ABM Fashions Ltd

1143&1145, Konabari, Kashimpur Road, Gazipur
(24.004348N, 90.320706E)

27th October 2015

Observations

Highly stressed column due to finishes build up in toilet area.

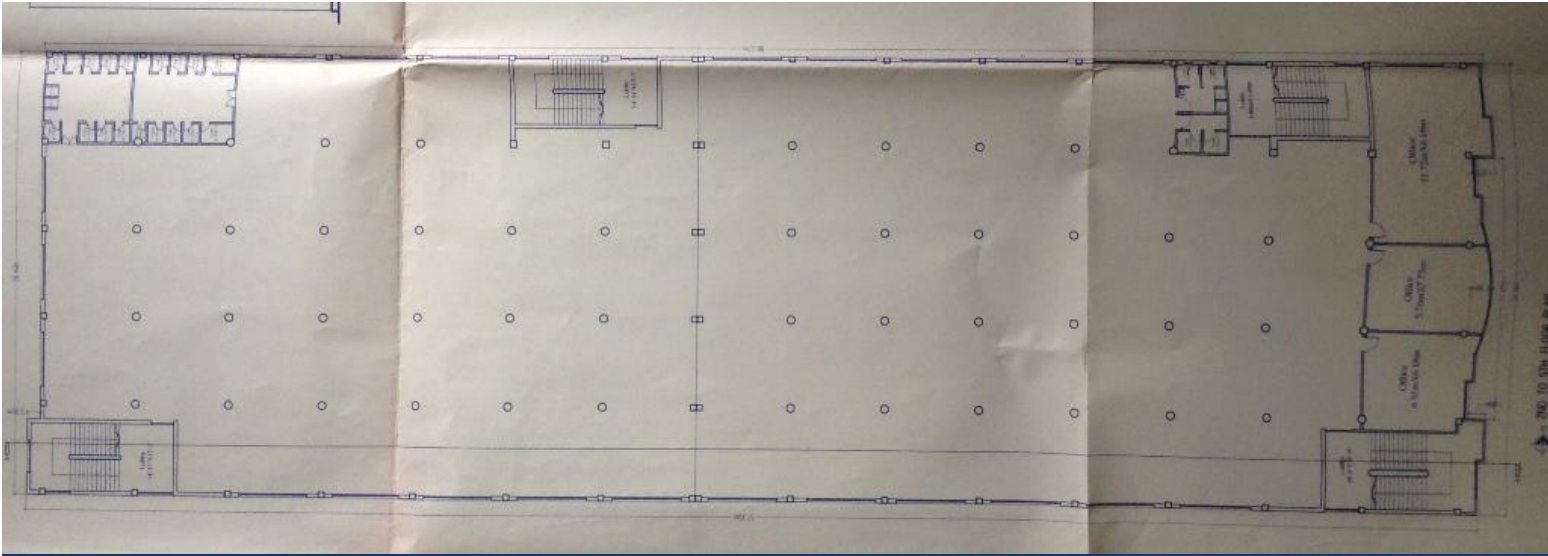
- Highly Stressed column on grid P-6 at toilet area with cantilever due to finishes build up. (Applies both to column capacity and punching shear of slab)
- Discrepancies between permit drawings and as constructed drawings.(Cantilevers are not shown on drawings and stairs beams are missing. It is not known if column head shear reinforcement is present)
- Beam missing at middle of north stair at 1st floor.
- Uncontrolled storage at 5th floor.

| Item No. | Observation | Recommended Action Plan | Recommended Timeline |
|----------|--|--|------------------------|
| 1 | Column on grid P-6 appears to be critically stressed both in capacity and punching shear. Verify concrete strength in columns. | Do not carry out any further fit out works in the toilets in the area of column P6 until design check has been carried out. | Immediate - Now |
| 2 | Column on grid P-6 appears to be critically stressed both in capacity and punching shear. Verify concrete strength in columns. | Factory Engineer to carry out a detailed check on the loading and actual capacity of column on grid P6. A check is to be carried out on site to ascertain if shear reinforcement has been provided in the slab at the column head. | 6-weeks |
| 3 | Column on grid P-6 appears to be critically stressed both in capacity and punching shear. Verify concrete strength in columns. | Verify insitu concrete strengths either by 100mm diameter cores or existing cylinder strength data for column P-6. | 6-weeks |
| 4 | Column on grid P-6 appears to be critically stressed both in capacity and punching shear. Verify concrete strength in columns. | Make structural alterations if required as advised by Factory Engineer | 6-months |

Cantilever at South

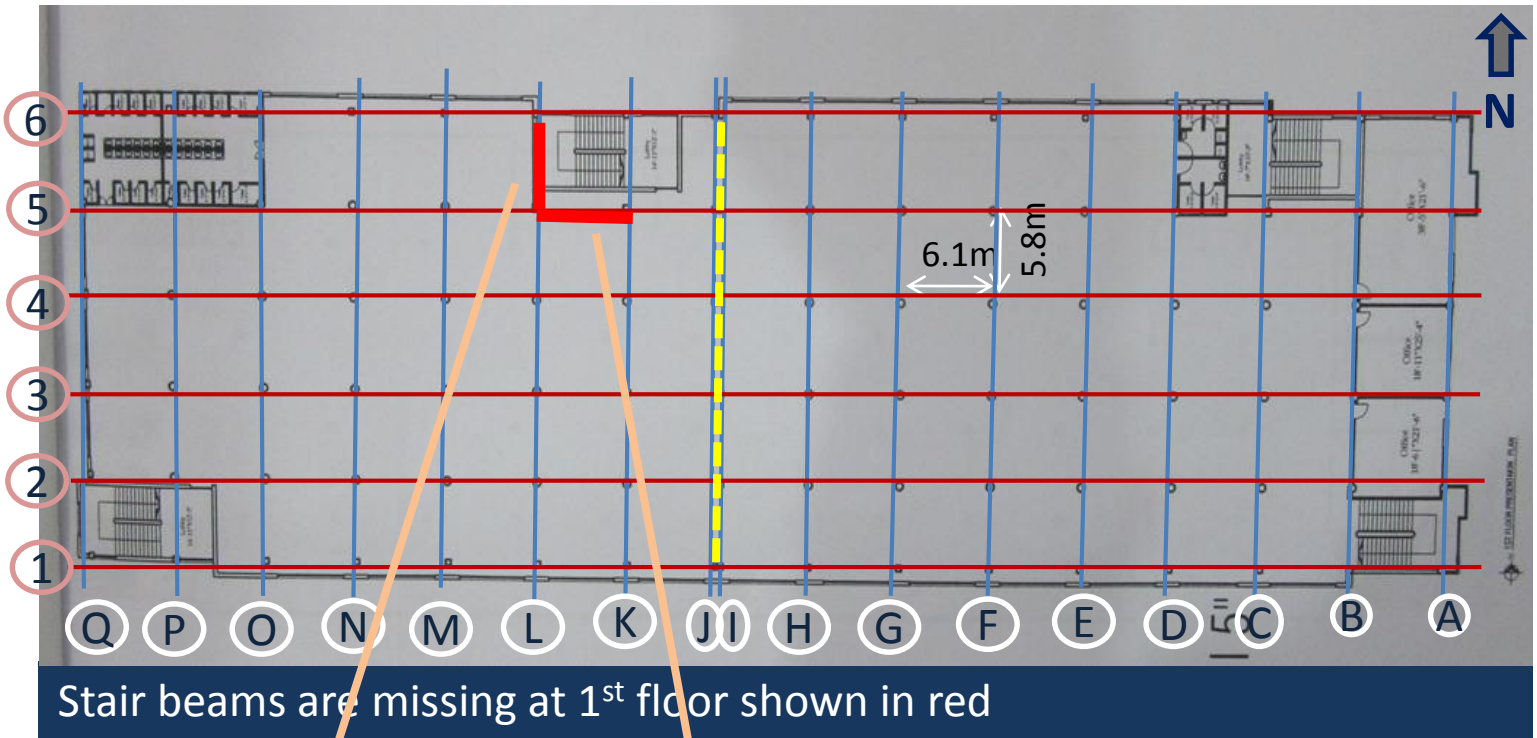
Permit drawing do not show cantilevers at north and south

| Item No. | Observation | Recommended Action Plan | Recommended Timeline |
|----------|---|---|------------------------|
| 5 | Discrepancies between drawings and as built structure. Possible punching shear problem on edge and central columns. | Factory Engineer to check on site if shear reinforcement has been put into the slab at column heads both at the perimeter and the middle of the slab. | Immediate - Now |
| 6 | Discrepancies between drawings and as built structure. Possible punching shear problem on edge and central columns. | Make any structural alterations as advised by Factory Engineer. | 6-weeks |
| 7 | Discrepancies between drawings and as built structure. Possible punching shear problem on edge and central columns. | Factory Engineer to fully compare the building drawings with the as-built structure. | 6-weeks |
| 8 | Discrepancies between drawings and as built structure. Possible punching shear problem on edge and central columns. | Update drawings to fully record the as-built condition of the building. | 6-months |
